DUKE POWER COMPANY, ET AL.

(Catawba Nuclear Station, Units
1 and 2)

PALMETTO ALLIANCE AND CAROLINA ENVIRONMENTAL
STUDY GROUP TESTIMONY OF STEVEN C. SHOLLY ON
EMERGENCY PLANNING CONTENTION NUMBER ELEVEN

Figure I-11. Conditional Probability of Exceeding Whole Body Dose Versus Distance. Probabilities are Conditional on a Core Melt Accident (5×10^{-5}).

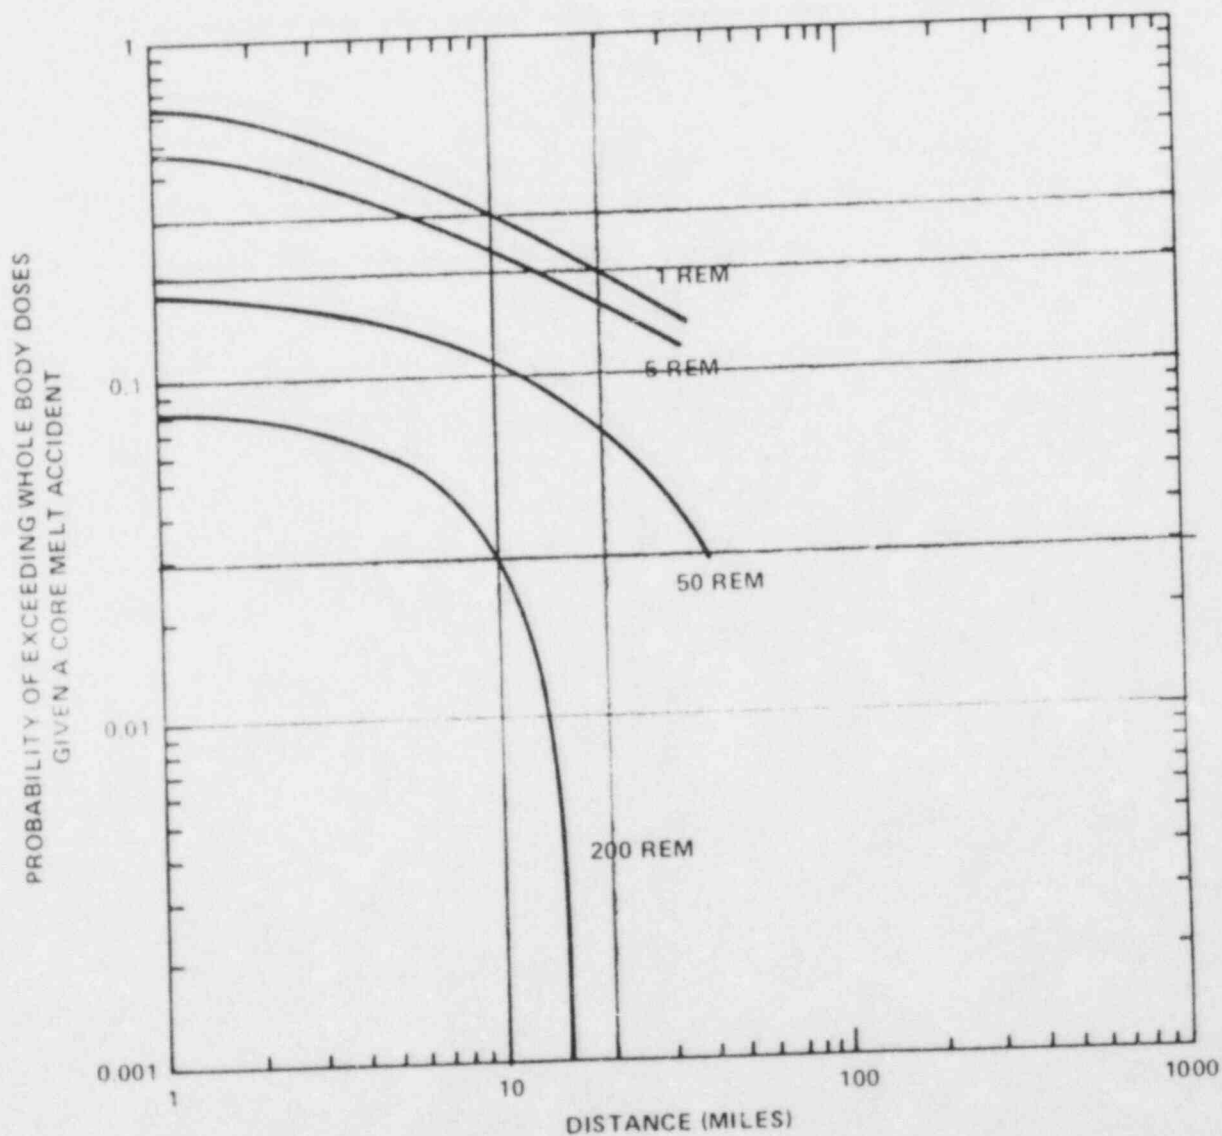
Figure I-11 from NUREG-0396 (attached to this testimony) [NUREG-0396, p. I-38] presents curves of the conditional probability of whole body dose versus distance for core melt accidents. These curves are explicitly based on the source terms and relative probabilities of the Reactor Safety Study release categories PWR-1 through PWR-7. The curves result from a probabilistic weighting of separate curves for each release category. The doses were calculated based on straight line plume trajectory and an assumption of no protective actions, and were calculated using the CRAC ("Calculation of Reactor Accident

From Figure I-11 of NUREG-0396 conclusions for Catawba are possible if the assumption is made that these results reasonably represent Catawba. This assumption is somewhat questionable since the results are for release characteristics and relative probabilities for Surry rather than for a reactor with an ice condenser containment. The release likelihoods for release categories PWR-1 through PWR-3, however, are not very different between the Surry and Sequoyah analyses (there are large differences for release categories PWR-4 and PWR-5). Another consideration is that the curves will be slightly conservative for Catawba since the WASH-1400 consequence calculations were carried out for a 3,200 MWt core, whereas the Catawba core is somewhat larger at 3412 MWt.

This reservation aside, given a core melt accident there is about a 30% likelihood (about one chance in 3) of exceeding the 1 Rem whole body PAG at 10 miles, and about a 20% likelihood (about 1 chance in 5) of exceeding the 5 Rem whole body PAG at 10 miles. Another way of stating this is that there is about 1 chance in 5 to 1 chance in 10 of needing to implement protective actions beyond the present 10-mile plume EPZ given a core melt accident.

Further, again based on Figure I-11 from NUREG-0396, there is about a 10% likelihood (one chance in 10) of exceeding a 50 Rem whole body dose at 10 miles; such a dose is a factor of ten greater than the upper bound whole body PAG dose of 5 Rem. The likelihood of exceeding a dose of 200 Rem whole body (which is in the range of early fatality threshold without medical

Figure 5.2 Conditional Mean Projected Whole Body Dose Versus Distance for Sheltering and Evacuation Strategies. Projected Doses are Conditional on a PWR "Melt-Through" Release (PWR 6 and 7).

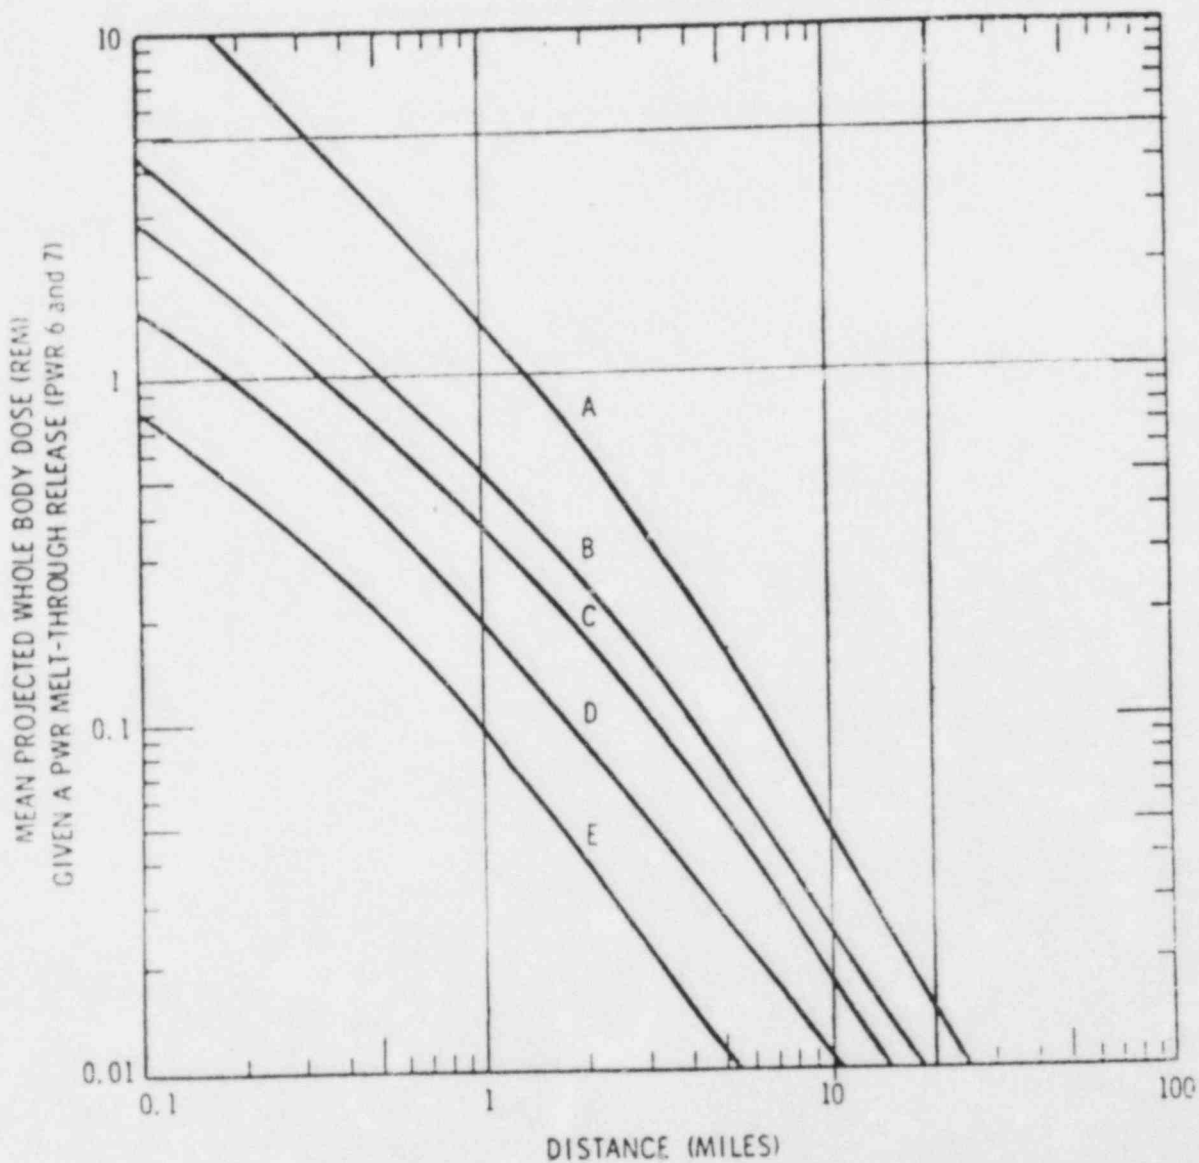
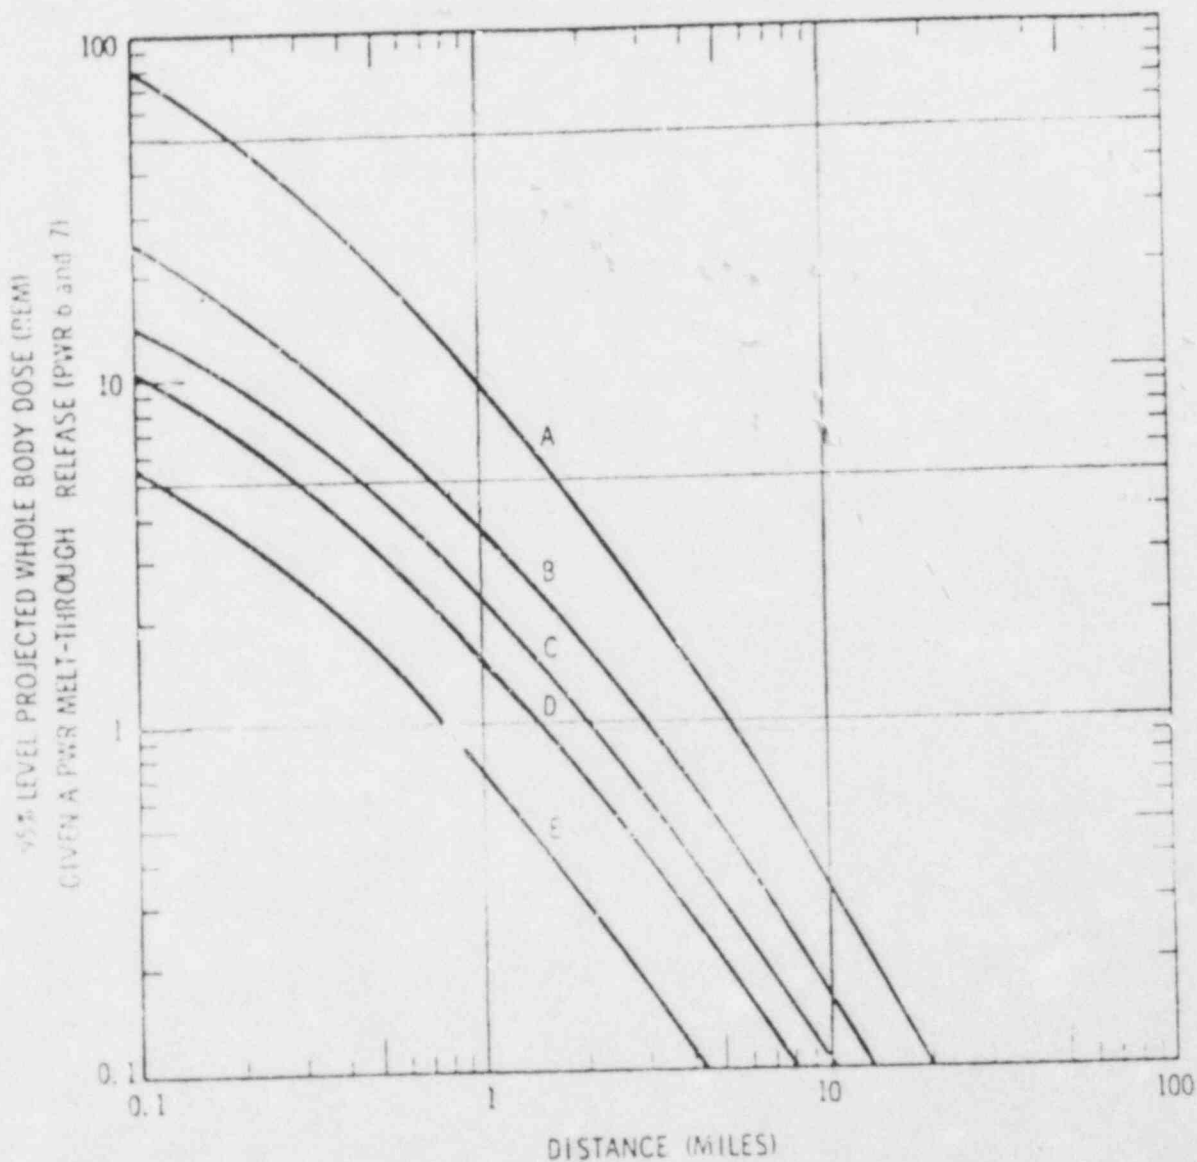
Given a core melt accident with a basemat melt through release (examining Figures 5.2 and 5.3 from NUREG/CR-1131, using Curve A representing no protective actions), the average distance to which the 1 and 5 Rem whole body PAG doses will be reached is about 1-2 miles and 0.4 miles, respectively. In the 95% case, the distances are about 6 miles and 2 miles, respectively. In addition, in the 95% case (equalled or exceeded only 5% of the time), the distance to which a 50 Rem whole body dose is exceeded is about 0.2 miles.

Figure 5.9 Conditional Mean Projected Whole Body Dose Versus Distance for Sheltering and Evacuation Strategies. — Projected doses are Conditional on a PWR "Atmospheric" Release (PWR 1-5).

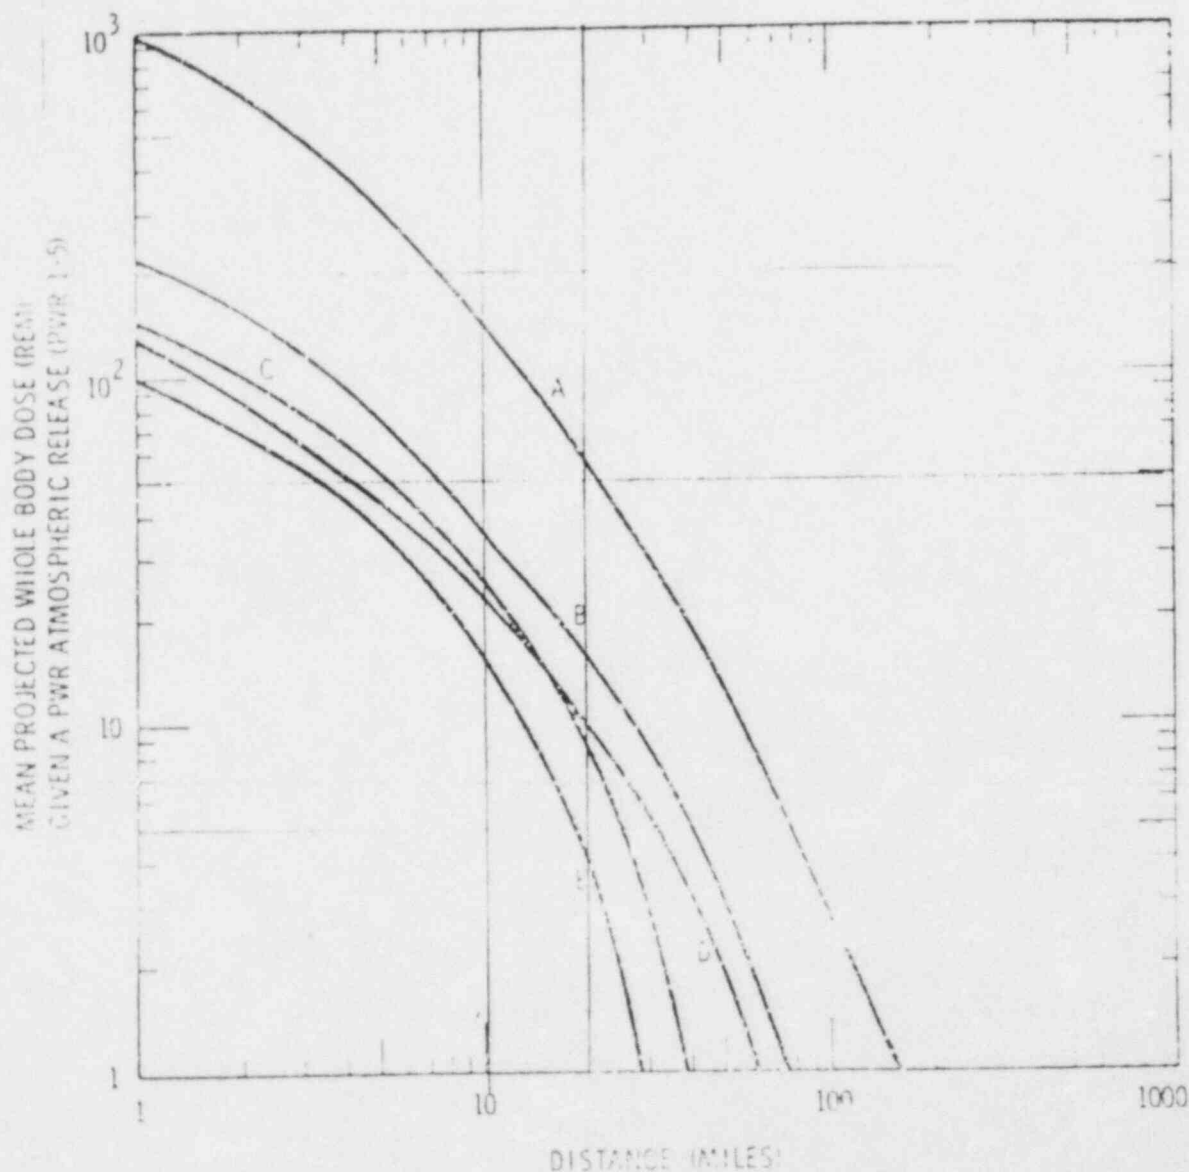
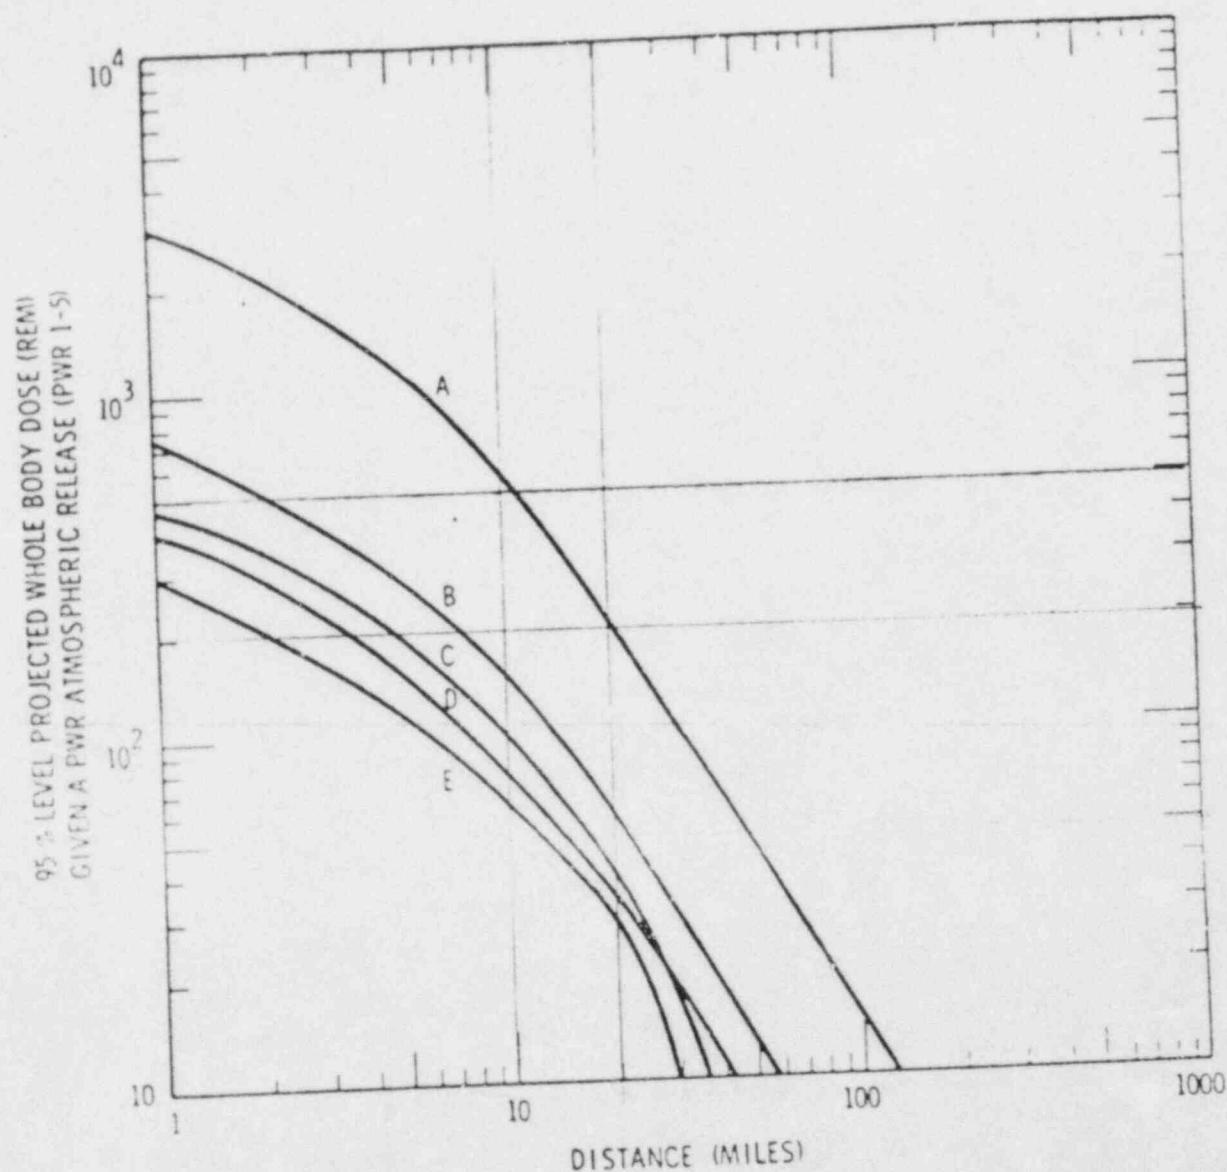
Given a core melt accident with a release to the atmosphere (examining Figures 5.9 and 5.10 from NUREG/CR-1131, using Curve A representing no protective actions), the average distance to which the 1 and 5 Rem whole body PAG is reached is about 100 miles and 80 miles, respectively. Moreover, a 50 Rem whole body dose is reached at about 20 miles, and a 200 Rem whole body dose is reached at about 8 miles. In addition, a 500 Rem whole body dose (510 Rem is the so-called "LD-50/60" dose in WASH-1400, that dose sufficient to result in early

However, as Figures 5.9 and 5.10 from NUREG/CR-1131 demonstrate, sheltering with relocation six hours after plume passage provides roughly equivalent protection to evacuation. Curves B and D represent sheltering with different sheltering factors, and Curves C and E represent evacuation at an effective speed of 10 mph (the NRC Staff's consequence estimates in NUREG-0921 assume an effective speed of 6.7 mph based on evacuation time estimates for the existing 10 mile EPZ) with delay times of five and three hours, respectively.

According to NUREG/CR-2239 [NUREG/CR-2239, pp. A-5 and A-7], Catawba was placed into a sheltering region with shielding factors of 0.6 and 0.2 for the Sandia siting study calculations. Thus, the actual sheltering result for Catawba would lie somewhere between curves B and D on Figures 5.9 and 5.10 in NUREG/CR-1131.
